DART SERVICE INSTRUCTION

TO AMEND INSTALLATION INSTRUCTIONS IIN-D350-822 REV. 1 AND INSTRUCTIONS FOR CONTINUED AIRWORTHINESS ICA-D350-822 REV. 7 OR LATER APPROVED REVISION

The purpose of this Service Instruction is to facilitate the permanent removal of the D350-822-011 PA100 PUREair System using the DSI 9843-011 PA100 Close Out Kit.

FIGURE 1 - D5079-1 PLACARD

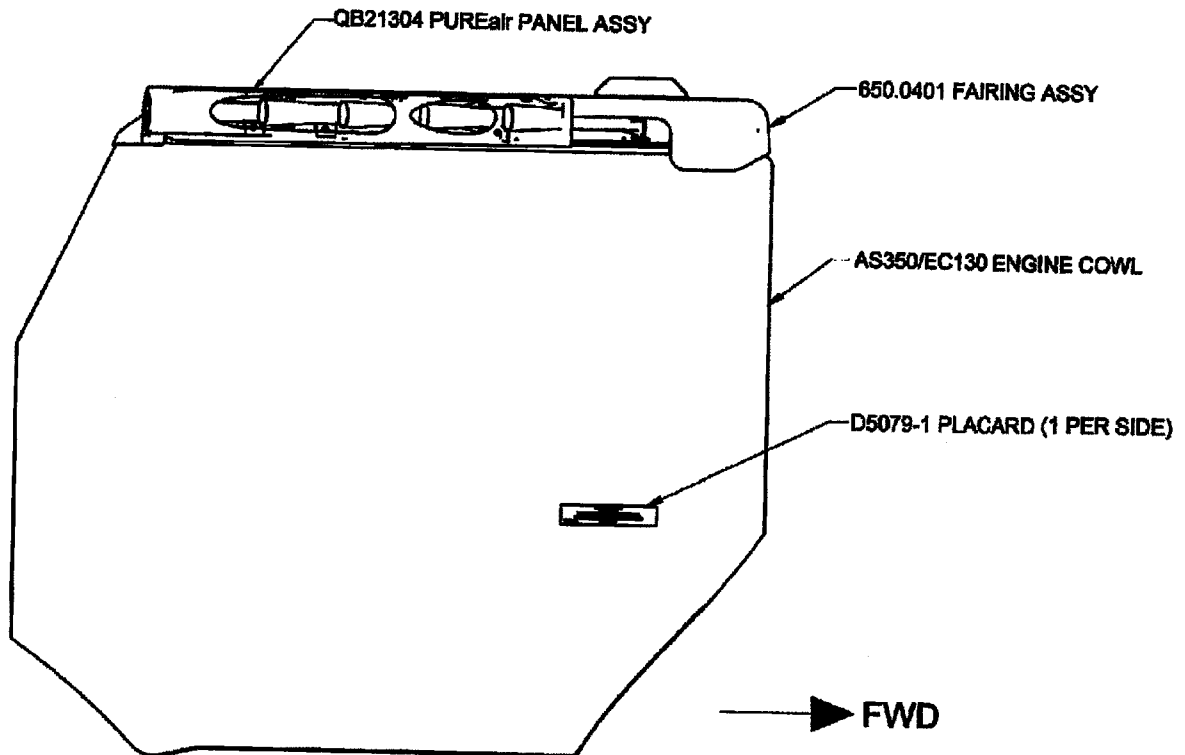
3. Remove the D5079-1 Placards shown in Figure 1.
4. Remove the D4931-X Engine Fitting shown in Figure 8 and re-install any adapters or blanking plates required for the P2 outlet on the RH side of the engine by re-using the existing gasket, if serviceable.

FIGURE 2 - D5744-041 CLOSE OUT PLATE ASSY & D5744-3 RETAINER INSTALLATION

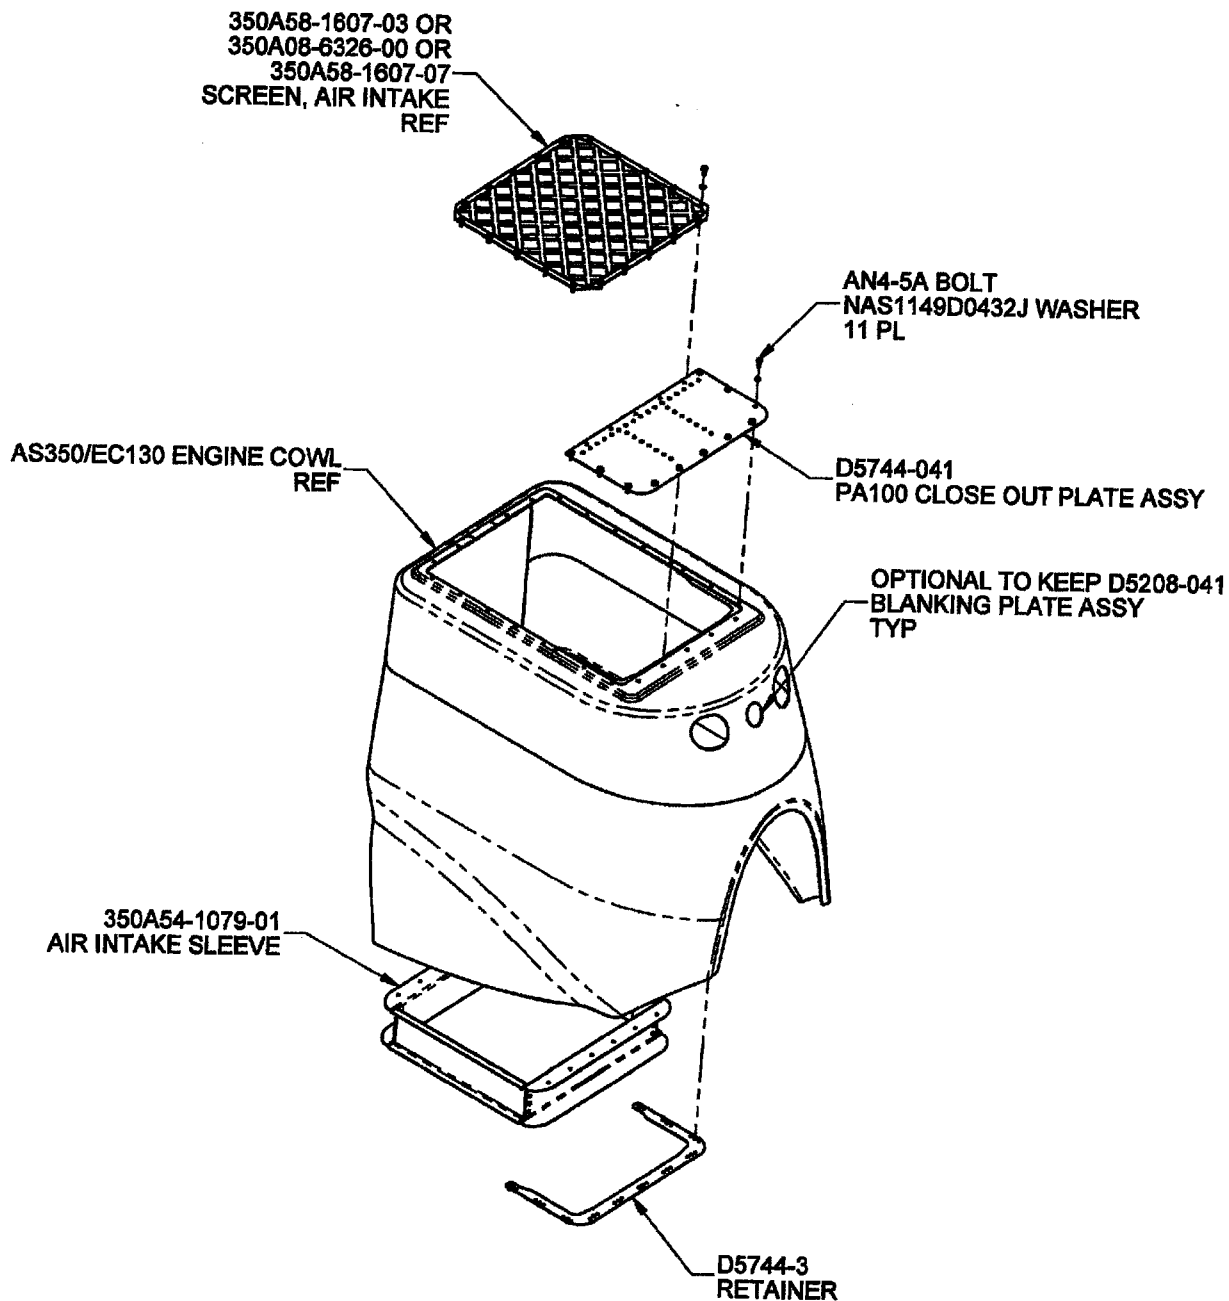
13. Prime and paint D5744-041 PA100 Close Out Plate to match aircraft paint scheme per the Aircraft Maintenance Manual.
14. Install the D5744-041 PA100 Close Out Plate on the upper cowl per Figure 2. Torque AN4 bolts 50-70 in-lbs (5.6-7.9 N-m).

FIGURE 3 - D5744-041 CLOSE OUT PLATE ASSY & D5744-3 RETAINER HOLE TRANSFER

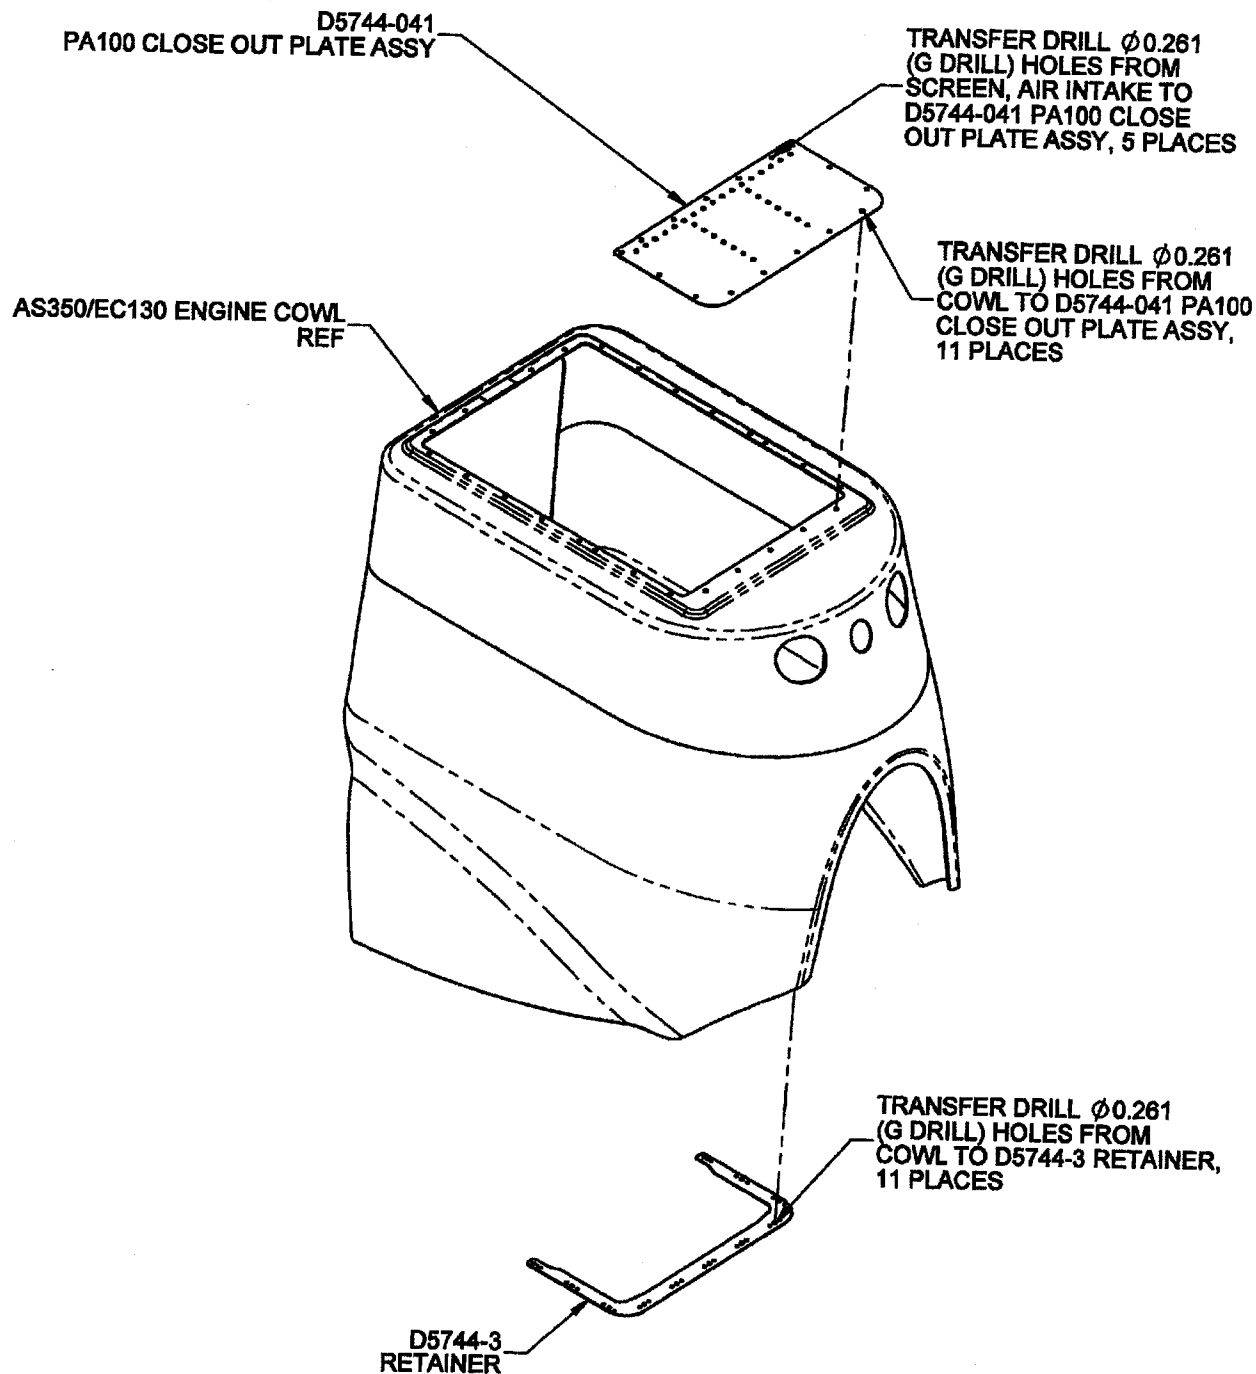
7. Remove the FOD Screen per Section 71.5 of ICA-D350-822 (Ref. Figure 7).
8. Transfer Drill 11 x $\phi 0.261$ " - 0.266" (G-H drill) holes from cowl to D5744-041 PA100 Close Out Plate Assy as shown in Figure 3.

9. Transfer Drill 5 x $\phi 0.261$ " - 0.266" (G-H drill) holes from air intake screen to D5744-041 PA100 Close Out Plate Assy as shown in Figure 3.
10. Transfer Drill 11 x $\phi 0.261$ " - 0.266" (G-H drill) holes from cowl to D5744-3 Retainer as shown in Figure 3.

FIGURE 4 - D5744-3 RETAINER PREPARATION

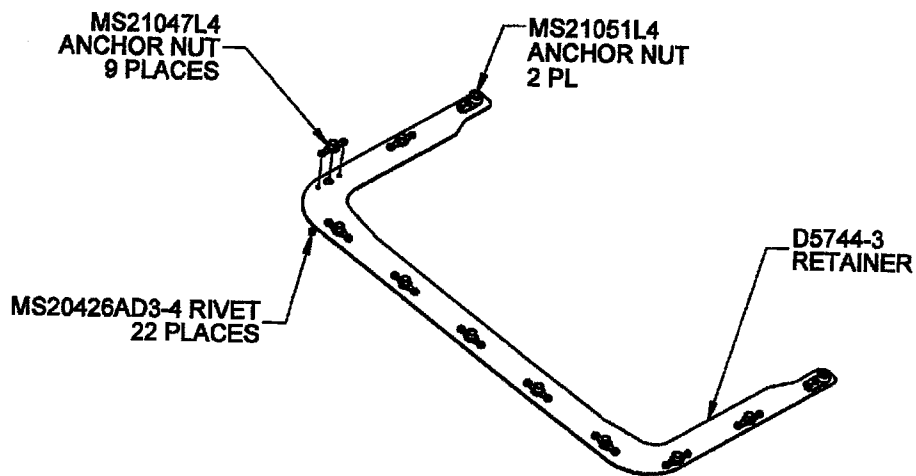
11. Transfer Drill 1 x $\phi 0.261$ " - 0.266" (G-H drill) hole from the Air Intake Screen to D5744-9 Retainer as shown in Figure 5.
12. Install 9 x MS21047L4 anchor nuts and 2 x MS21051L4 anchor nuts onto D5744-3 Retainer as shown in Figure 4. Deburr all holes and remove any debris from the work surface. Touch up the affected area using chemical film (Alodine 1200 or 1201) per MIL-DTL-5541 prior to installing the anchor nuts.

FIGURE 5 - D5744-9 BLANKING PLATE INSTALLATION

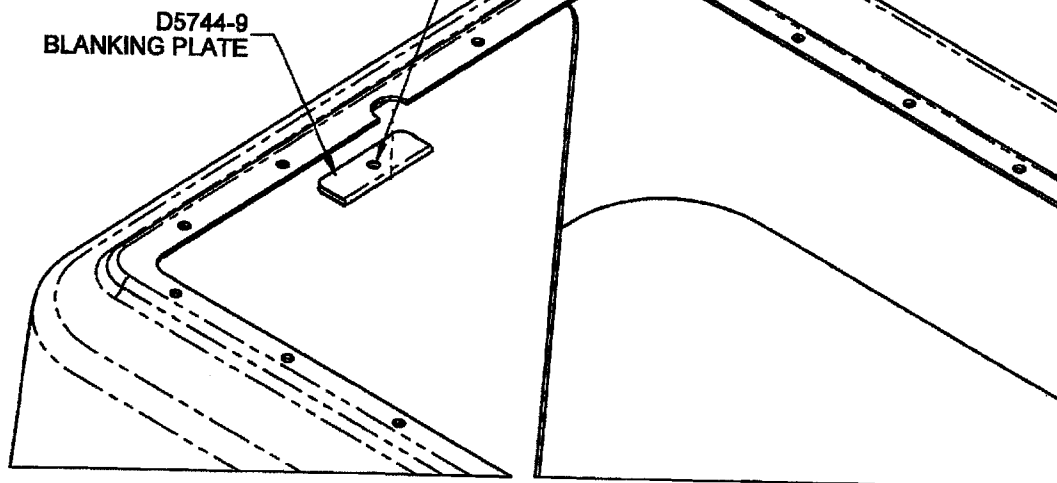
15. Bond the D5744-9 Blanking Plate to the upper cowl in the location shown in Figure 5, using a suitable adhesive (like CB200 Acrylic Structural Adhesive) per the Aircraft Maintenance Manual. Cure per manufacturer's instructions.
16. Install the Airbus p/n 350A54-1608-2 or 350A08-1607-03 or 350A08-6326-00 or 350A58-1607-07 Air Intake Screen and the 350A54-1079-01 Air Inlet Sleeve on the upper cowl per the Aircraft Maintenance Manual.
17. Install the 350A54-1201-01 Air Intake Duct and 350A54-1084-21 or 704A39-821-041 or 4-21-7933 Air Intake Seal per the Aircraft Maintenance Manual.
18. Update the Aircraft Log Book to indicate the installation of the DSI 9843-011 PA100 Close-out Kit and adjust Weight and Balance record for the aircraft with the Weight and Balance data provided in Section 3.0 of this document.

TRANSFER DRILL $\phi 0.261$ (G DRILL) HOLE FROM MESH SCREEN TO D5744-9 BLANKING PLATE, 1 PLACE

FIGURE 6 - PA100 PARTS REMOVAL

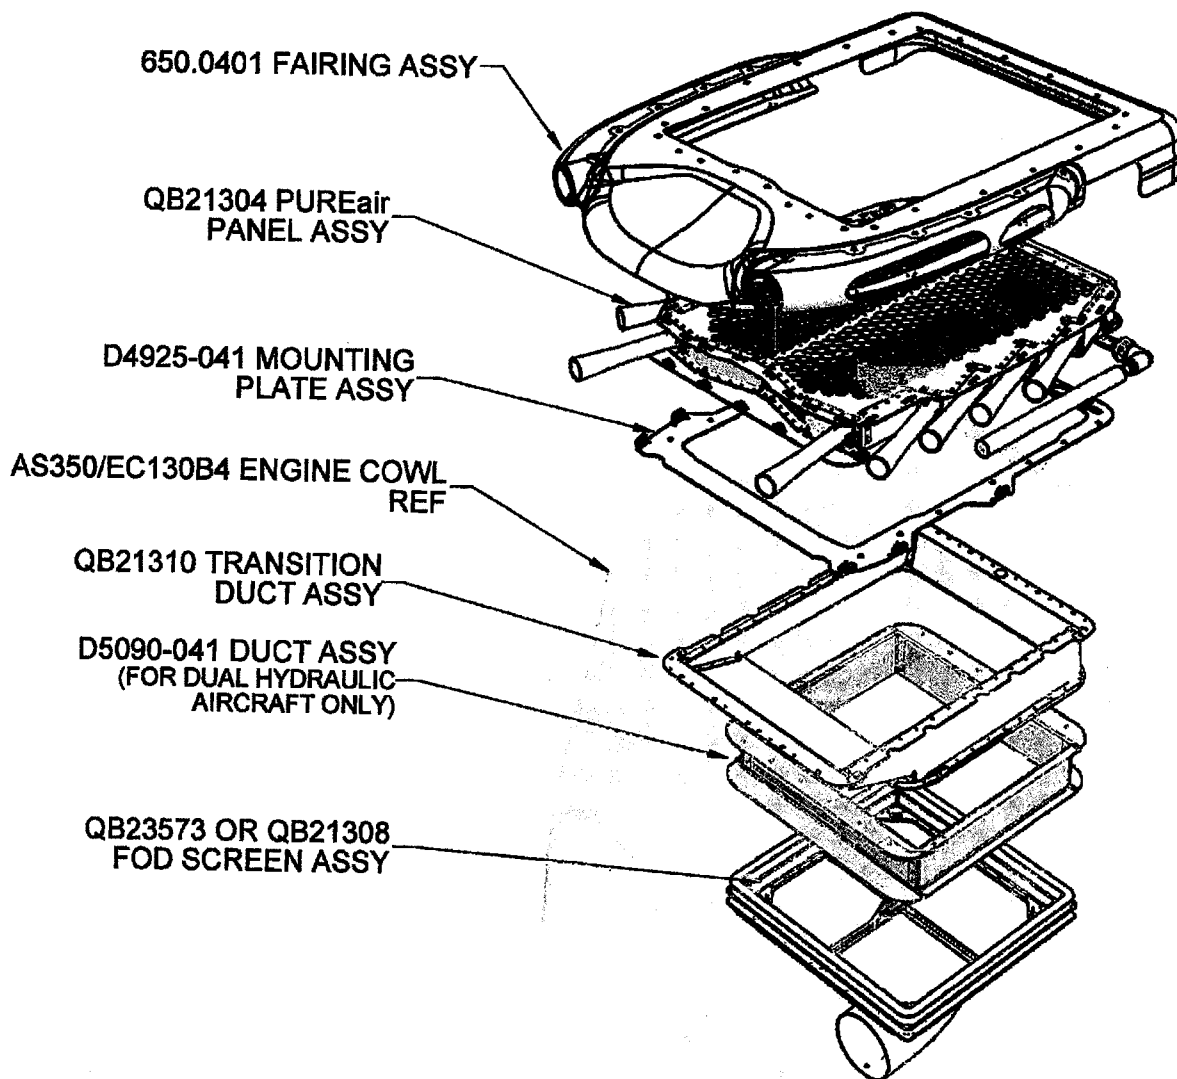
5. Remove the QB21310 Transition Duct and the D5090-041 Duct Assembly if applicable per Figure 6.
6. Remove the Air Intake Seal per the Aircraft Maintenance Manual.

FIGURE 8 - D4931-X ENGINE FITTING REMOVAL

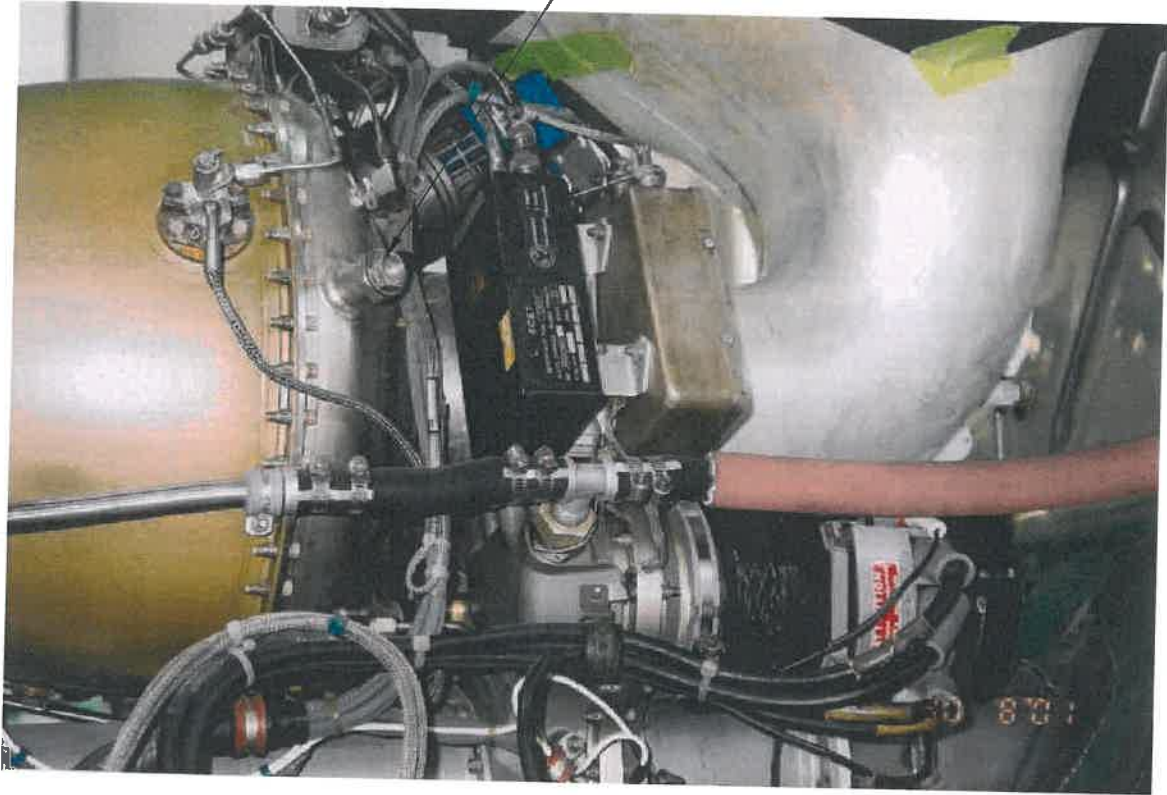
REMOVE D4931-X ENGINE FITTING
RE-INSTALL OEM FITTING
